Keystone RV Company

SAFETY ADVISORY # 17-303

Flame King Exterior Cook Top

Fig. 2

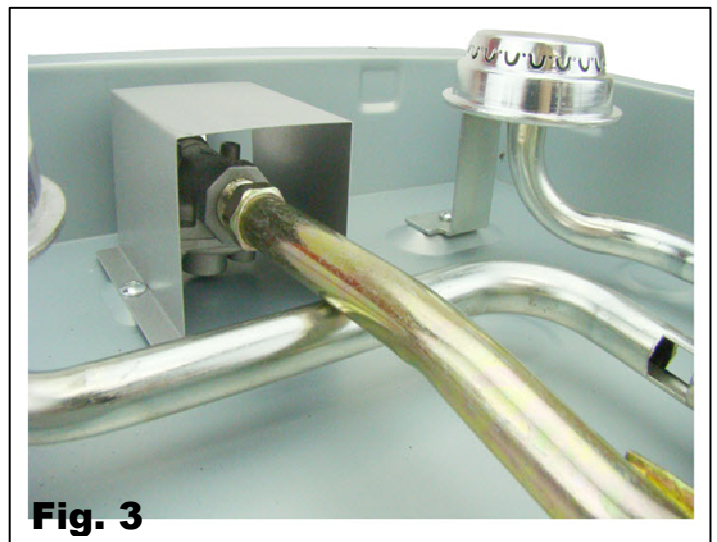
Remove burner cover and inspect regulator cover, Figures 2 and 3.

If no damage is found to the corrugated fiber board protector, replace the protector using KRV part number 586977. Remove 2 screws holding down the corrugated fiber board protector and reuse the screws when installing the metal protector.
